**From:** Govan, Tekia  
**Sent:** Thursday, November 21, 2013 4:20 PM  
**To:** FermiCOL Resource  
**Subject:** FW: Scanned Package Given to Staff (Part 5 of 6)  
**Attachments:** Audited Materials 11-21-2013 - Part 5.pdf

Insert Figure 3.7.1-251 to Figure 3.7.1-255

Figure 3.7.1-251 Normalized Arias Intensity and Estimates of Equivalent Stationary Duration for Calculating the PSD for the Spectrally Matched Horizontal (H1 and H2) Components Compatible with the Fermi 3 RB/FB Enhanced SCOR FIRS

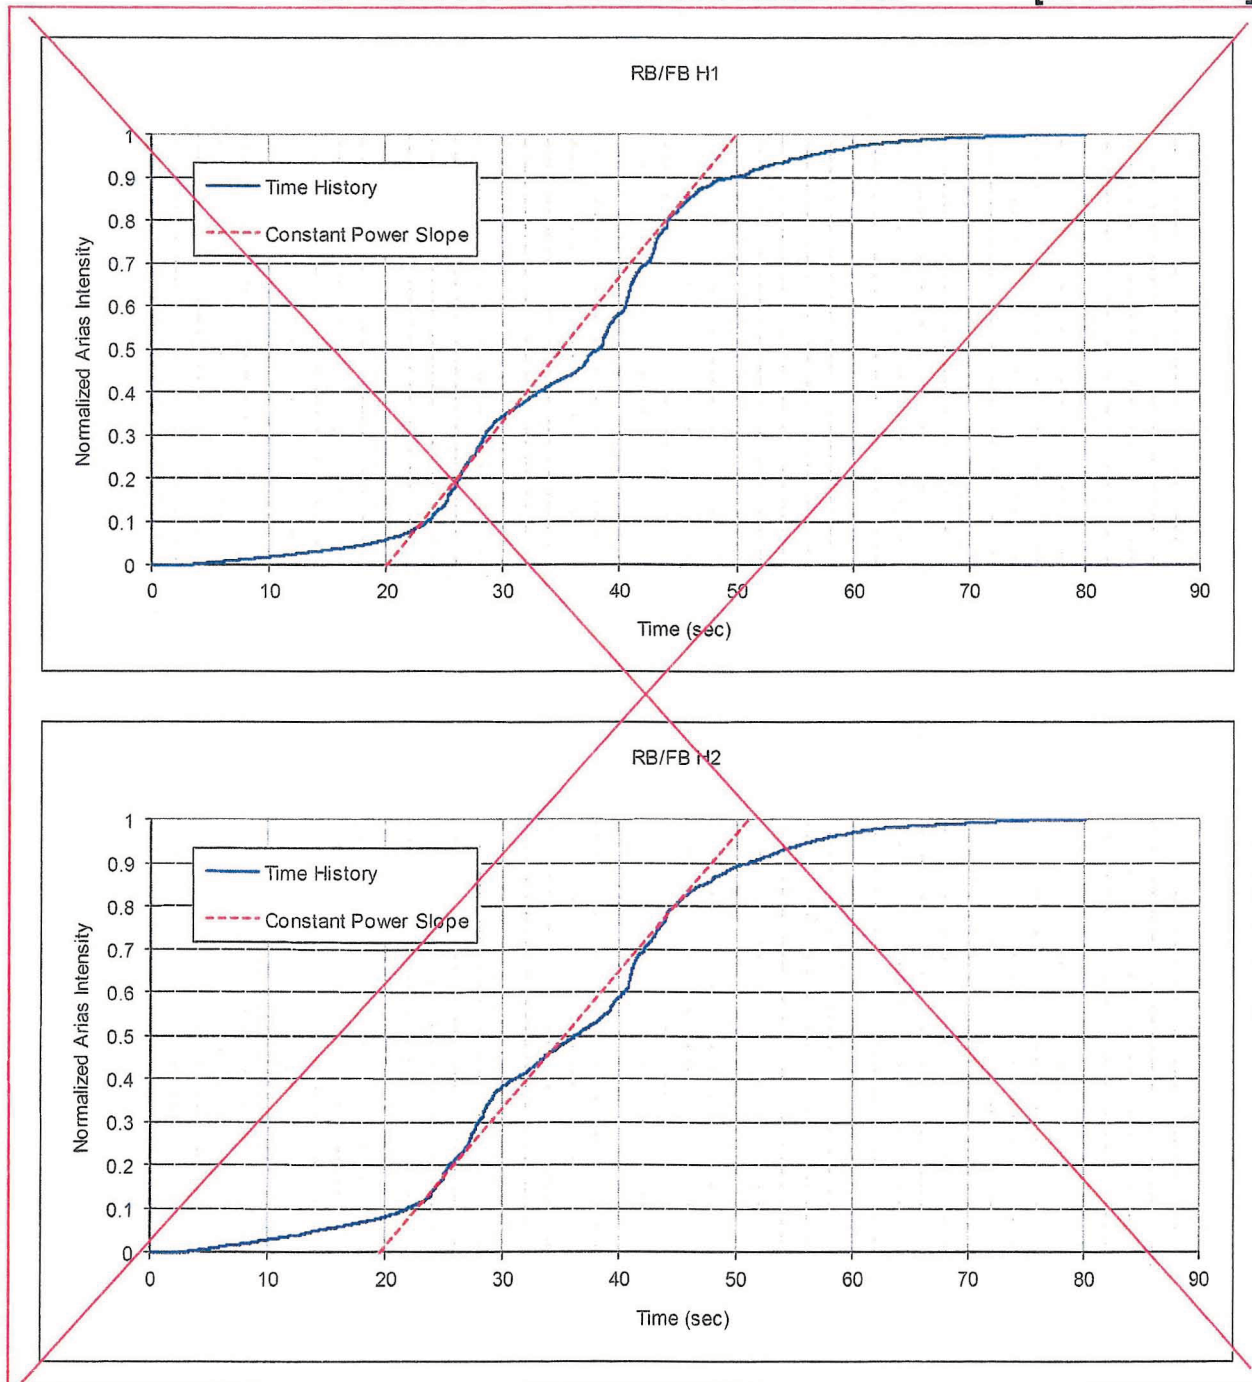
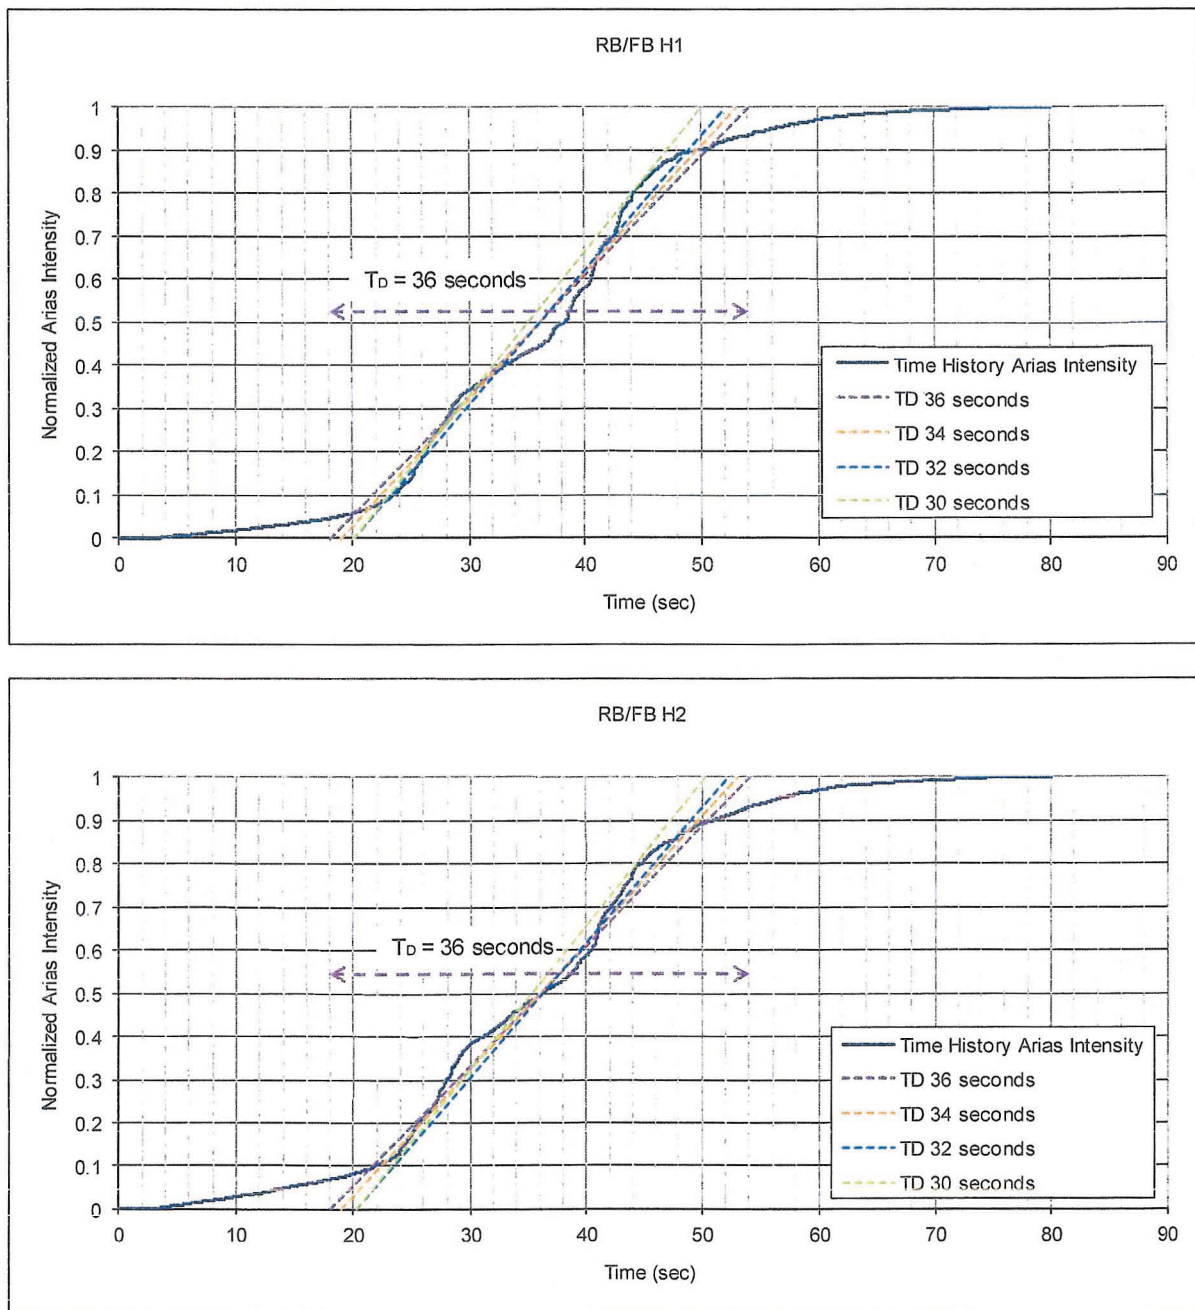
**Figure 3.7.1-251** ~~Slope of Near Constant Power used to Estimate Durations of 30 and 31.5 Seconds for Calculating the PSD for the Spectrally Matched Horizontal (H1 and H2) Components Compatible with the Fermi 3 RB/FB Enhanced SCOR FIRS~~ [EF3 SUP 3.7-1]

Figure 3.7.1-252 PSD Computed for the RB/FB H1 Component Spectrally Matched Time History (Enhanced SCOR FIRS) Using Full Duration Time Histories and Time Histories Windowed to an Equivalent Stationary Duration,  $T_D$

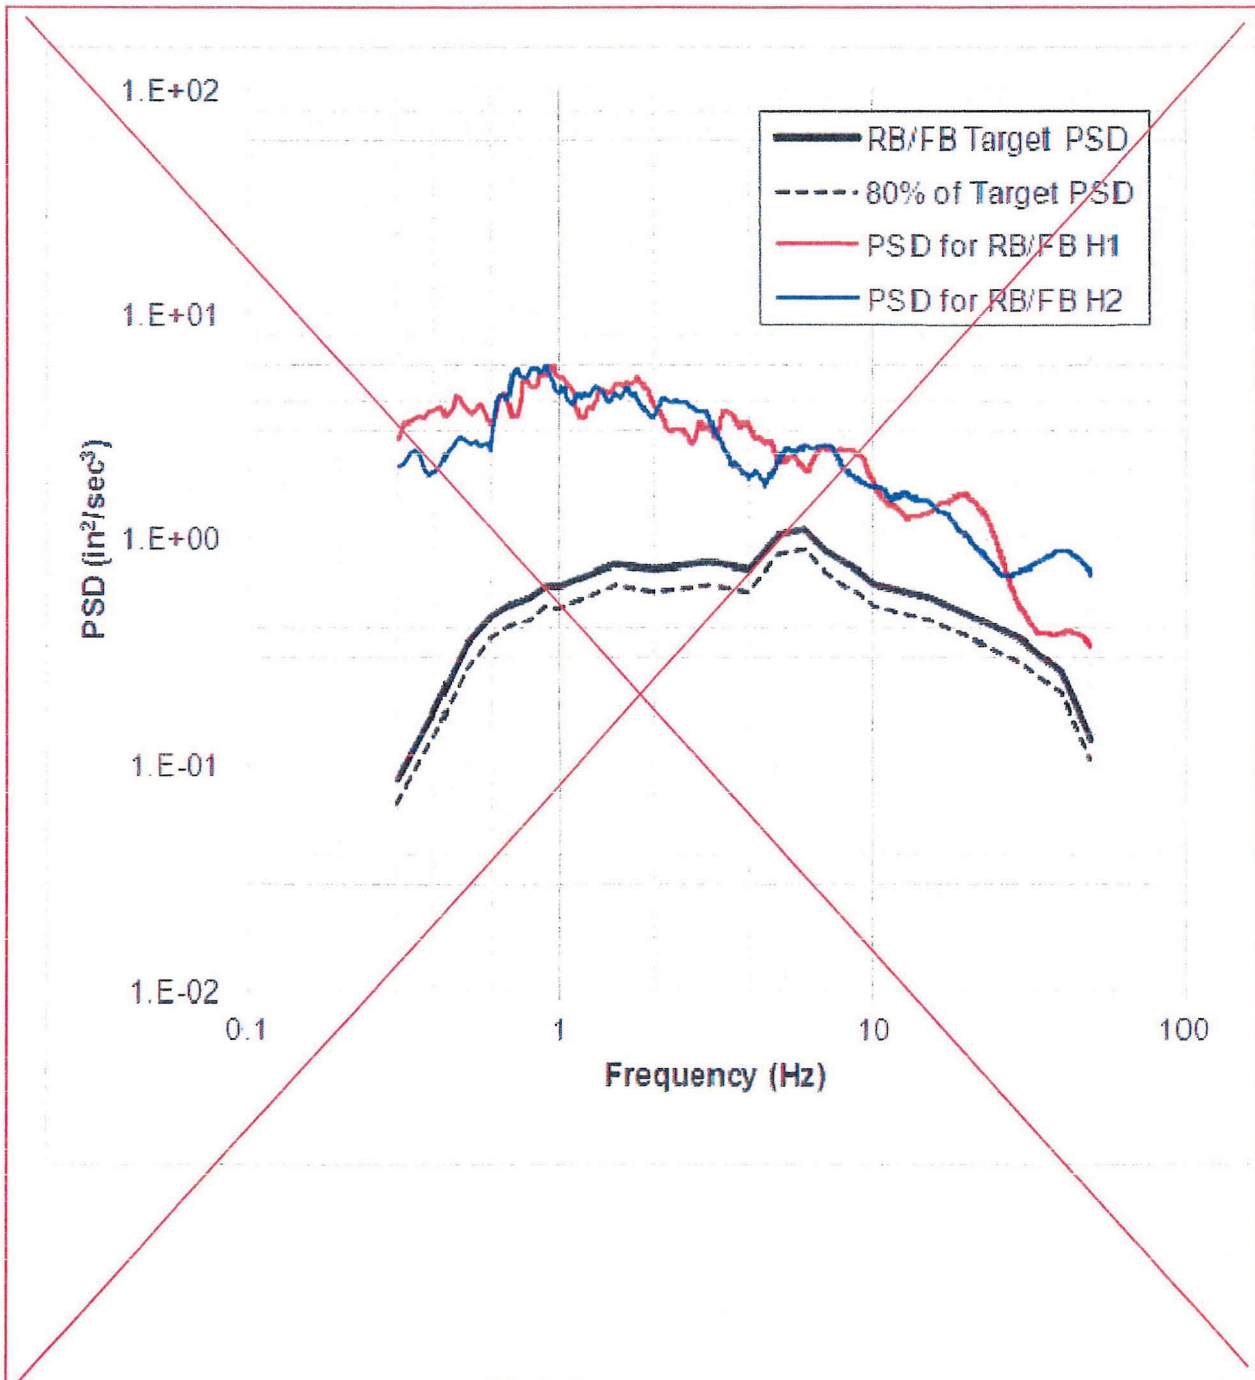
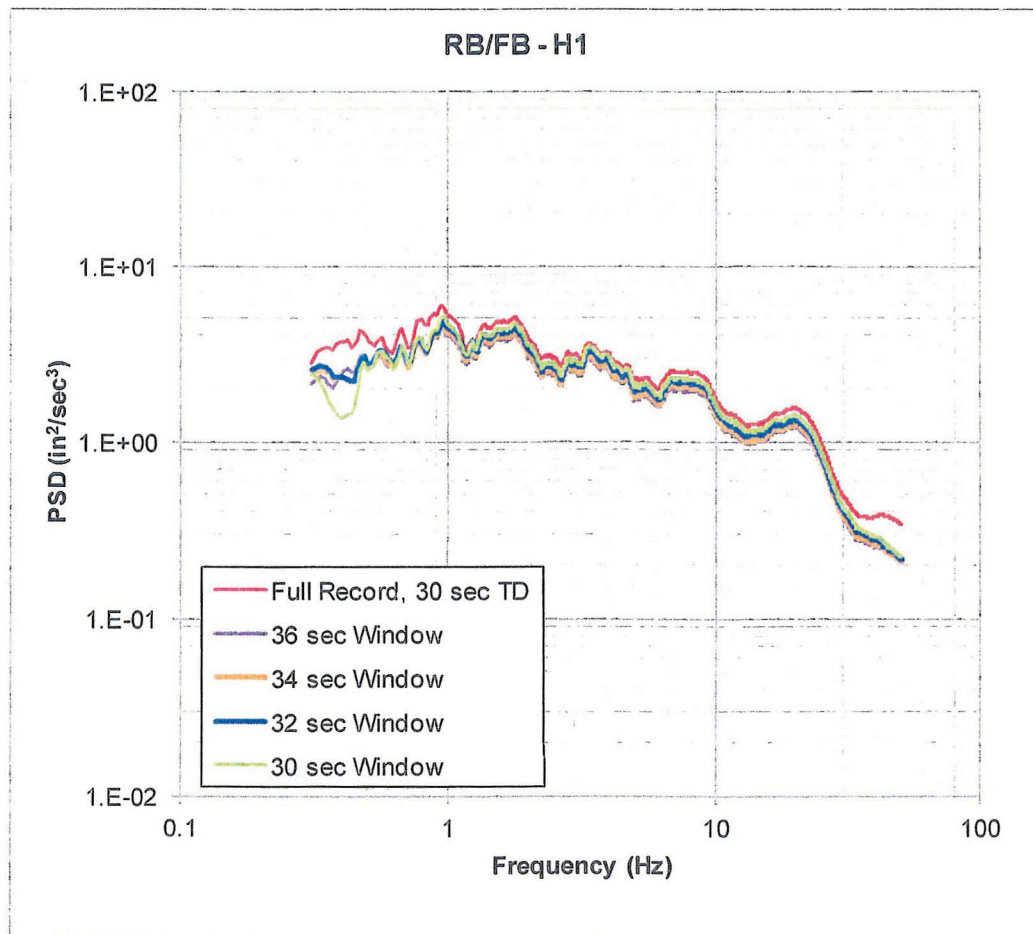
**Figure 3.7.1-252** ~~PSD for Spectrally Matched Time History Components (H1 and H2) Compatible with the Fermi 3 RB/FB Enhanced SCOR FIRS and Target PSD Based on Appendix B of SRP 3.7.1~~

Figure 3.7.1-253 PSD Computed for the RB/FB H2 Component Spectrally Matched Time History (Enhanced SCOR FIRS) Using Full Duration Time Histories and Time Histories Windowed to an Equivalent Stationary Duration,  $T_D$

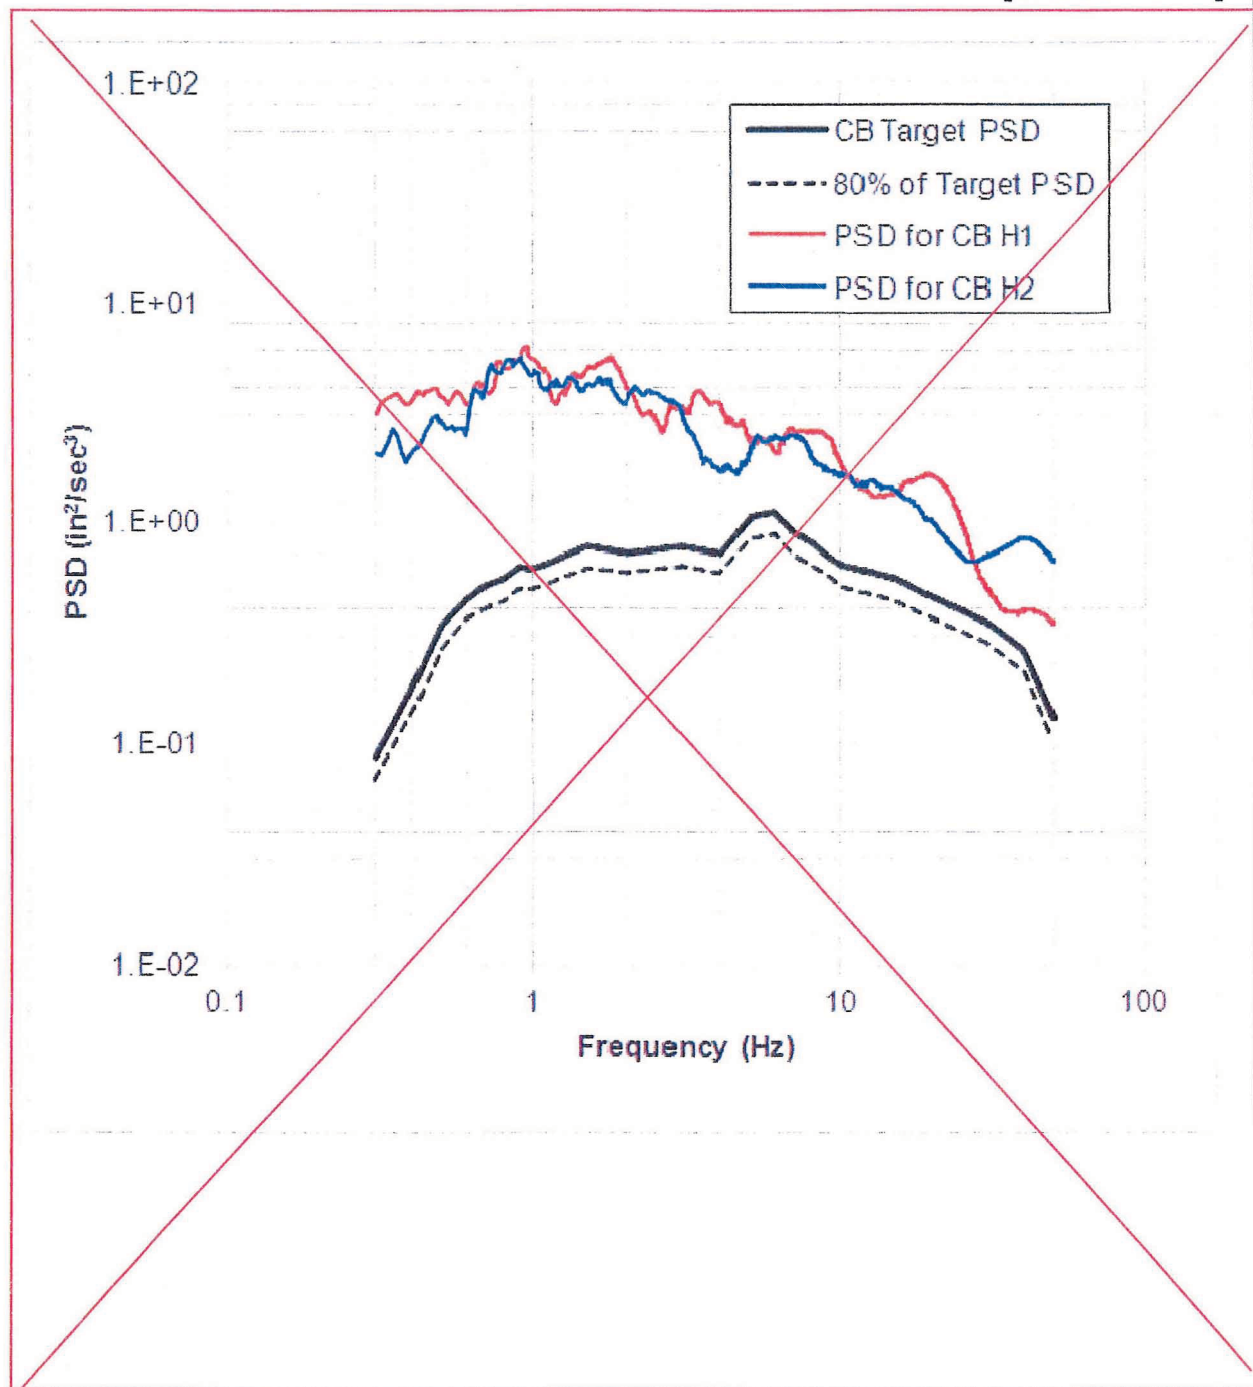
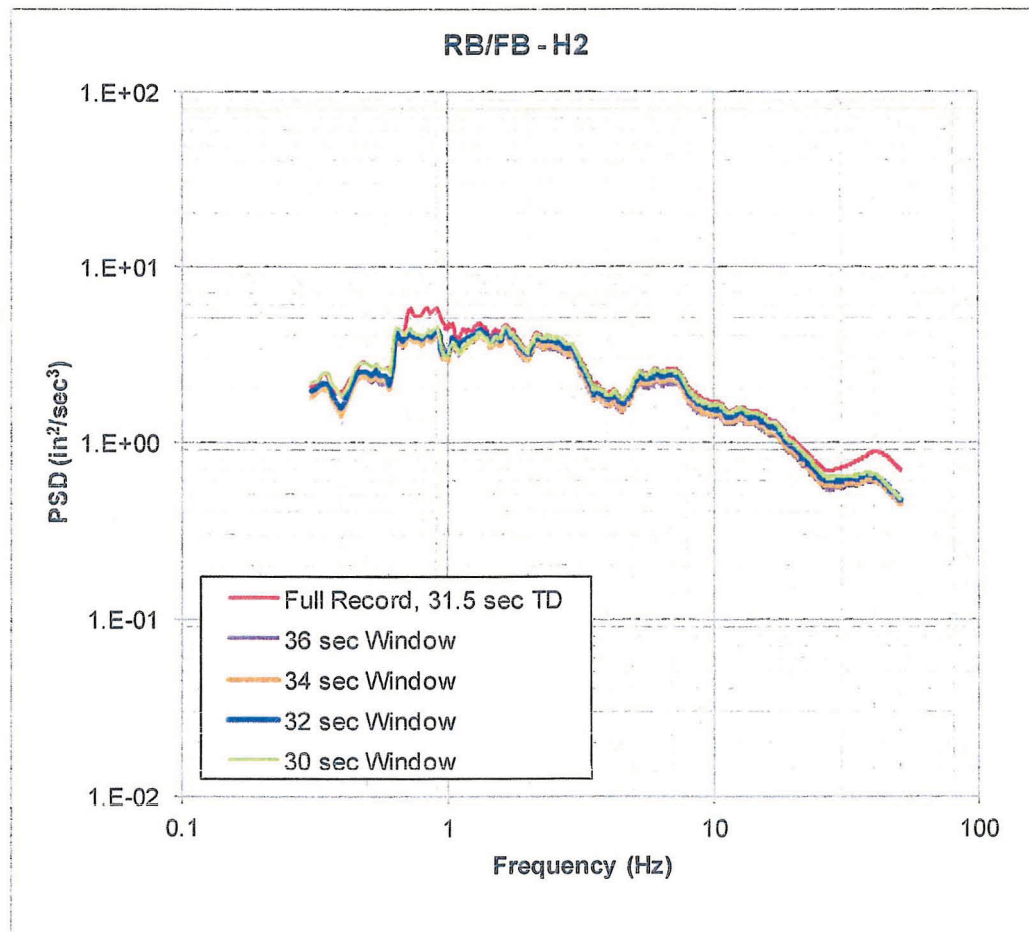
~~Figure 3.7.1-253 PSD for Spectrally Matched Time History Components (H1 and H2) Compatible with the Fermi 3 CBEnhanced SCOR FIRS and Target PSD Based on Appendix B of SRP 3.7.1~~

Figure 3.7.1-254 PSD Computed for the CB H1 Component Spectrally Matched Time History (Enhanced SCOR FIRS) Using Full Duration Time Histories and Time Histories Windowed to an Equivalent Stationary Duration,  $T_D$

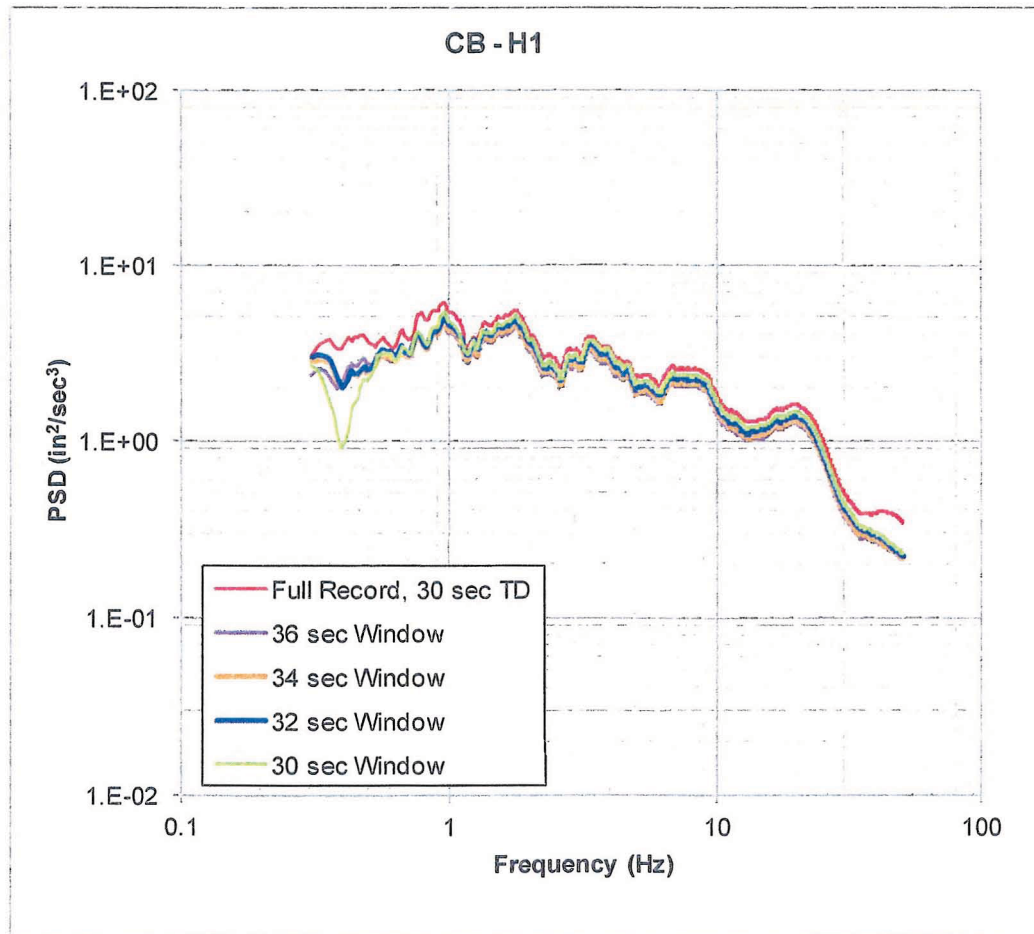
Insert Figure 3.7.1-251 to Figure 3.7.1-255  
(Continued)

Figure 3.7.1-255 PSD Computed for the CB H1 Component Spectrally Matched Time History (Enhanced SCOR FIRS) Using Full Duration Time Histories and Time Histories Windowed to an Equivalent Stationary Duration,  $T_D$

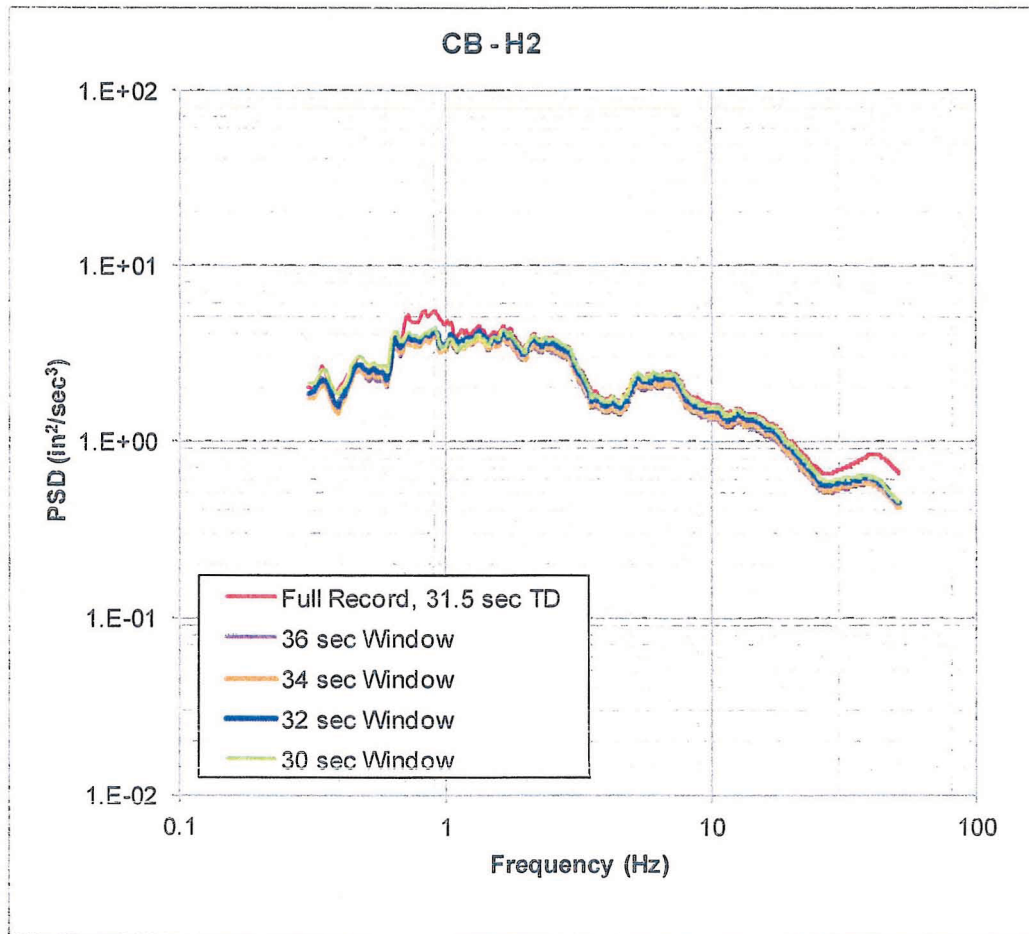
Insert Figure 3.7.1-251 to Figure 3.7.1-255  
(Continued)
